Project	IEEE 802.16 Broadband Wireless Access Working Group < http://ieee802.org/16 >	
Title	Proposals for Enhancements to IEEE 802.16 and 16a standards based on draft IEEE P802.16-2003/D0 and P802.16-2003D3	
Date Submitted	2003-09-09	
Source(s)	Barry Lewis, Paul Piggin and Philip Whitehead Radiant Networks PLC The Mansion, Chesterford Park Little Chesterford, Essex, CB10 1XL, UK	Voice: +44 1799 533600 Fax: +44 1799 533601 pw@radiantnetworks.co.uk
Re:	This document responds to the Call for Comments on editor's draft IEEE P802.16-2003/D0, announced on 2003-08-07. It includes a set of proposed enhancements to the standard.	
Abstract	This document contains a set of proposals for enhancements to the consolidated IEEE802.16 draft, which will produce a more comprehensive multipoint system standard. No new modes that are not already described in the standards are required. Nothing is deleted from existing standards. These proposals are defined in detail and could easily be added to the standard with only a small amount of change.

Proposals for Enhancements to IEEE 802.16 and 16a standards based on drafts IEEE P802.16-2003/D0 and P802.16-2003/D3

Barry Lewis, Paul Piggin and Philip Whiteh

Figure 1 Detailed configuration proposal for an optional timeslot frame structure better suited to point-to-point style of operation in “directional mesh” in IEEE802.16. NB Time-of-flight compensation not shown, nor is the DL-BTG.

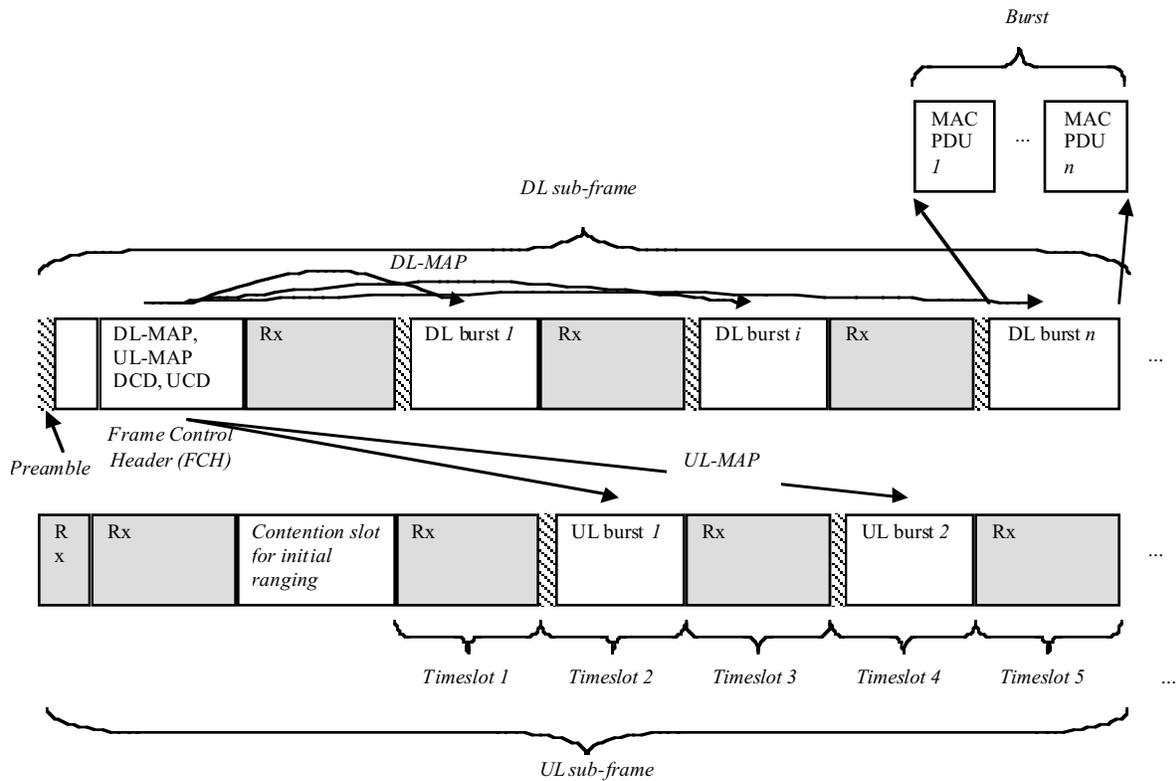
It is proposed to amend the standard to allow an FDD-like configuration to be used for point-to-point and mesh type operation. Table 1 (IEEE P802.16-2003/D0: section 1.2.4: page 2) needs to be amended accordingly to permit FDD-like operation in licence-exempt bands.

Although the standard allows for a mesh configuration and can be configured for a basic form of point-to-point operation, the burst structure for these configurations is potentially spectrally inefficient. An effective optional improvement can be described which allows freedom in defining where a DL or UL transmission occurs.

Include an optional burst structure with a TDD nature by using FDD-like half-duplex bursts, as described in IEEE C802.16d-2003/55 section 2.1. The following changes are proposed:

Figure 33 Example configuration for station 0. NB all links shown are duplex links, the arrowheads show BS to SS link termination orientation.

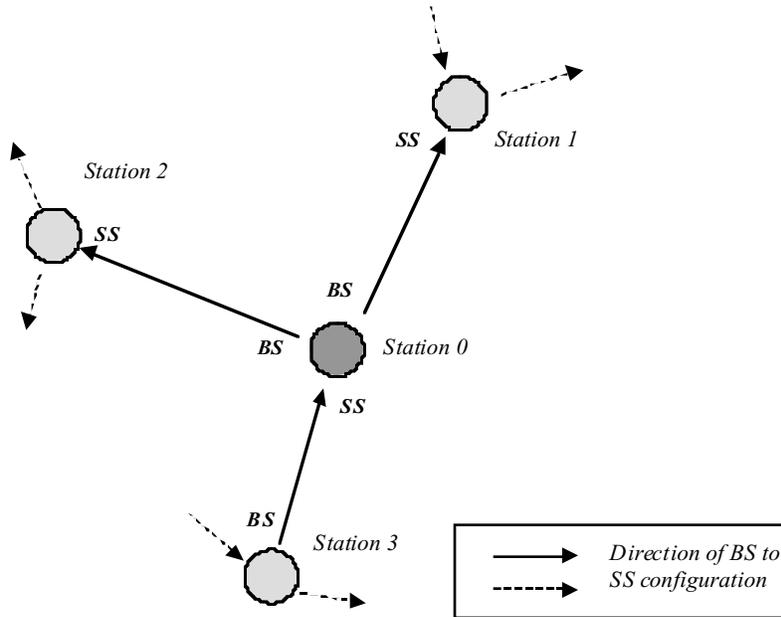
The solution is presented with an example configuration. This is shown in [Figure 3](#), with frame configuration given in [Figure 4](#). The solution provides station configuration and synchronization using a fixed reference e.g. GPS. The *station hold-off* respects the constraints of H-FDD and permits a preamble to be transmitted on every link at the start of the frame but not at the same time. This is part of a so-called *slotted preamble* section of the frame. The *frame control header* or FCH follows. It is likely that there will be a gap following the *slotted preamble* section before the start of the FCH (as shown in [Figure 4](#)). To achieve this gap (which is not expected as the FCH is expected straight after the frame preamble) a similar method used for the UL, where the *start alloc time* is used, is proposed. The UL-MAP is defined in Table 17 (IEEE P802.16-2003/D0: page 64) and provides an indication of the start of the UL allocation in the form of the *start alloc time*. It is intended to include this mechanism in the DL-MAP in Table 15 (IEEE P802.16-2003/D0: page 62). This parameter will be a 32bit representation of the start of the FCH in mini-slots (similar to the UL version), and will be added to the DL-MAP. The modified DL-MAP MAC message is shown in [Figure 2](#).

It is likely from such a configuration that there will be a gap between the frame preamble and the frame control header (FCH). It is proposed that the addition of a *start alloc time*, defined in the DL-MAP Table 15 (IEEE P802.16-2003/D0: page 62), provides an indication of the start of the FCH. This parameter will be 32bit representation of the start of the FCH in mini-slots (similar to the UL version). The modified DL-MAP is shown in IEEE C802.16d-03/55 figure 2.

Figure 55 Configuration of MAC messages used in power control.

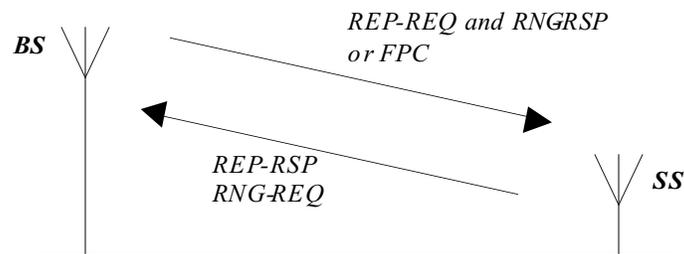
The REP-REQ and REP-RSP MAC message can be used for power control measurements; RNG-REQ and RNG-RSP ~~MAC messages~~ ~~or FPC MAC messages~~ are used for the implementation of power control commands. This is shown diagrammatically in ~~Figure 5~~ ~~Figure 5~~ ~~Figure 5~~ ~~Figure 5~~, and represents the current state of the IEEE802.16 standard. The REP-REQ can seek both power control and interference avoidance measurements. REP_RSP provides a report following the solicited request. As part of the *Generic header* in the MAC PDU (payload of the PHY burst) the CID can be used to address SS. Including these messages in the PHY burst payload will provide power control measurements for all timeslots, across all frequencies.

The IEEE802.16 standard should be extended to allow REP-REQ MAC messages to be sent by both the BS and SS, in addition both the BS and SS should be able to send REP-RSP MAC messages and be mandated to provide the necessary measurements. A similar proposal holds for the case that the RNG-REQ and RNG-RSP ~~or FPC~~ MAC messages ~~pair-are~~ used for power control.

The IEEE802.16 standard only supports power control in the UL direction. Efficient point-to-point style of operation inherent within mesh requires bi-directional power control. This will improve frequency reuse and coexistence (both intra-system and inter-system). In some bands such power control is mandated for regulatory compliance.

- Permit the SS to send REP-REQ MAC messages for power control measurement defined in section 6.4.2.3.33 (IEEE P802.16-2003/D0: page 93),
- Permit the BS to send REP-RSP MAC messages for power control measurement defined in section 6.4.2.3.33 (IEEE P802.16-2003/D0: page 93),

- ~~Permit the BS to send RNG-REQ MAC messages for power control action defined in section 6.4.2.3.5 (IEEE P802.16-2003/D0: page 65);~~
- Permit the SS to send **RNG-RSPFPC** MAC messages power control action defined in section 6.4.2.3.6 (IEEE P802.16-2003/D0: page 66),
- Permit BS to make measurements from the UL burst preamble and keep records of these measurements to produce REP-RSP MAC messages as in (IEEE P802.16-2003/D0: sections 8.3.2 (page 378), 8.4.8 (page 420), 8.5.11 (page 467)),
- Permit the SS to analyze REP-RSP MAC messages and generate **RNG-RSPFPC** MAC messages accordingly as defined in section 6.4.2.3.6 (IEEE P802.16-2003/D0: page 66).
- Permit the Channel Measurement Report/Response MAC messages, section 6.4.2.3.33 (IEEE P802.16-2003/D0: page 93), to be used above 11 GHz.
